Lee County, Florida
DEPARTMENT OF COMMUNITY DEVELOPMENT
ZONING SECTION
STAFF REPORT

Case Number: DCI2021-00014

Case Name: Williams Avenue CPD

Case Type: Planned Development Rezoning

WILLIAMS AVENUE CPD
MASTER CONCEPT PLAN A

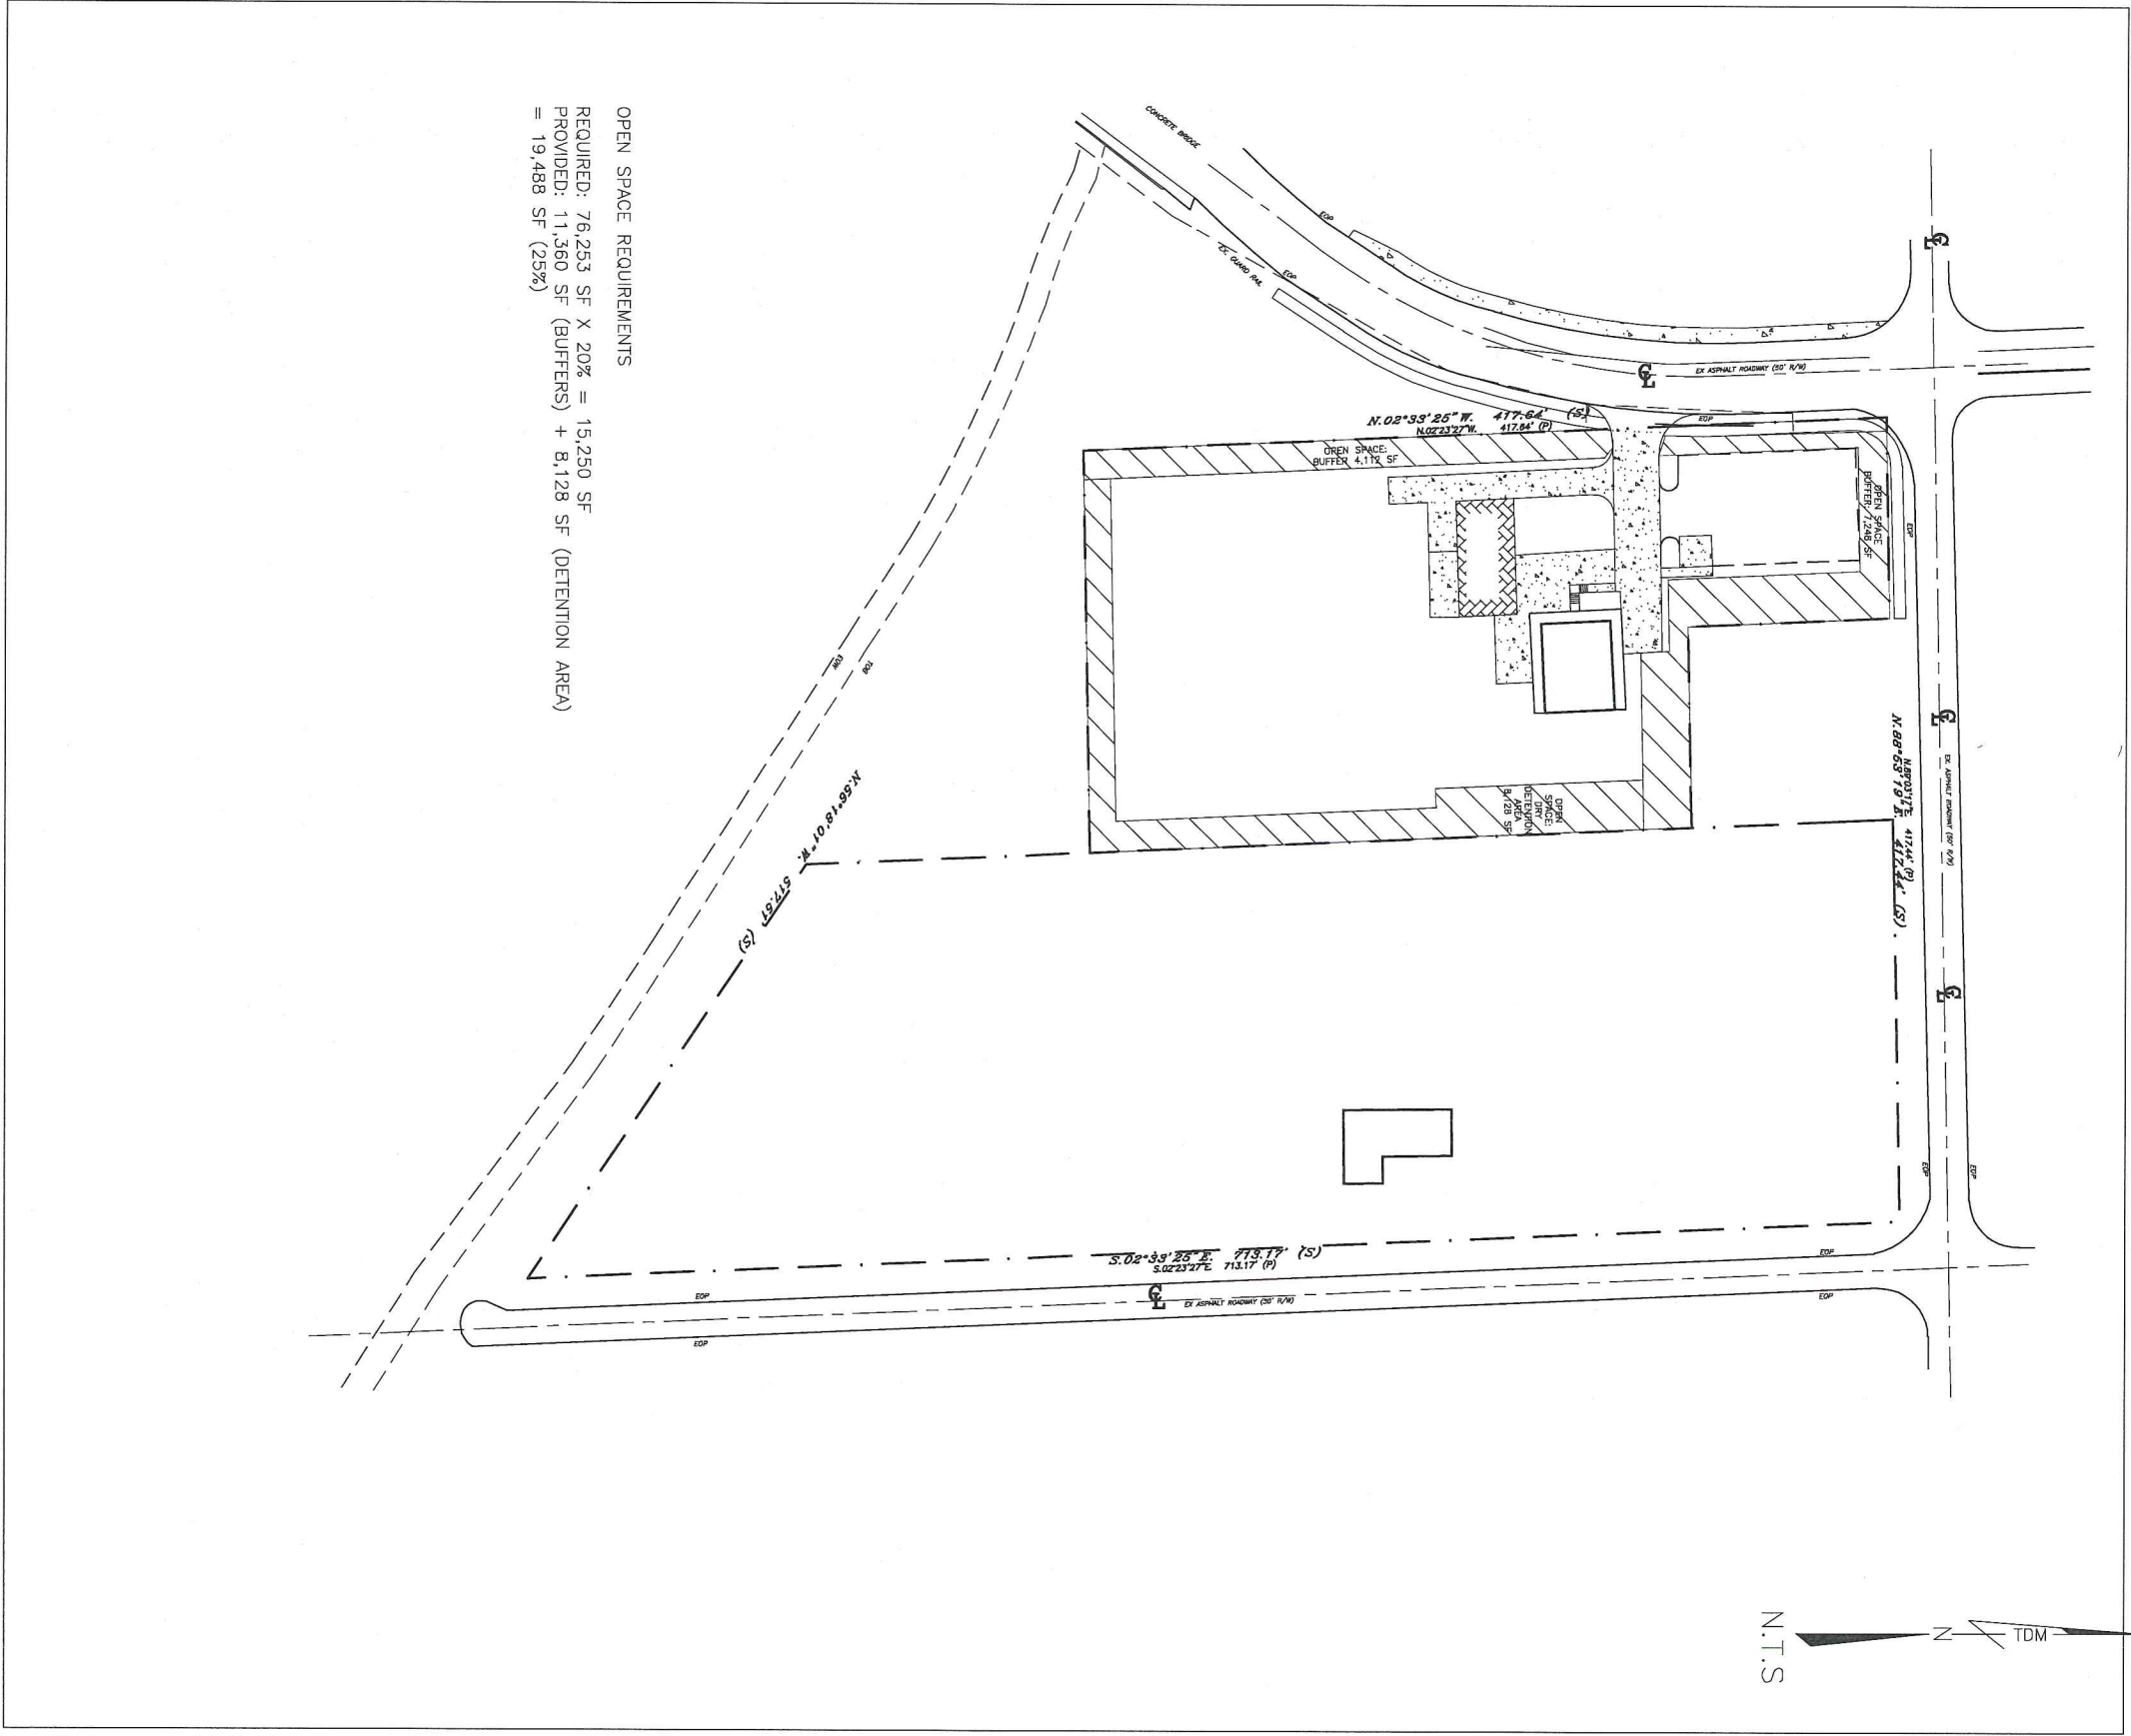
Staff recommends a **PARTIAL APPROVAL** of this deviation. Staff recommends denial of the request along the south property line abutting the residentially-zoned property and approval along the west property line parallel with Magnolia Avenue. The retail nursery is depicted in the southern area and should be screened with a required landscape buffer to provide compatibility between the residential lot and the

proposed commercial activity. The applicant conveys the idea that the nursery and its plant material will serve as a buffer. Relying on a commodity to serve this function, which is proposed to be cultivated and sold in a commercial capacity on the subject property, is not perceived as a sufficient safeguard along this southerly property line.
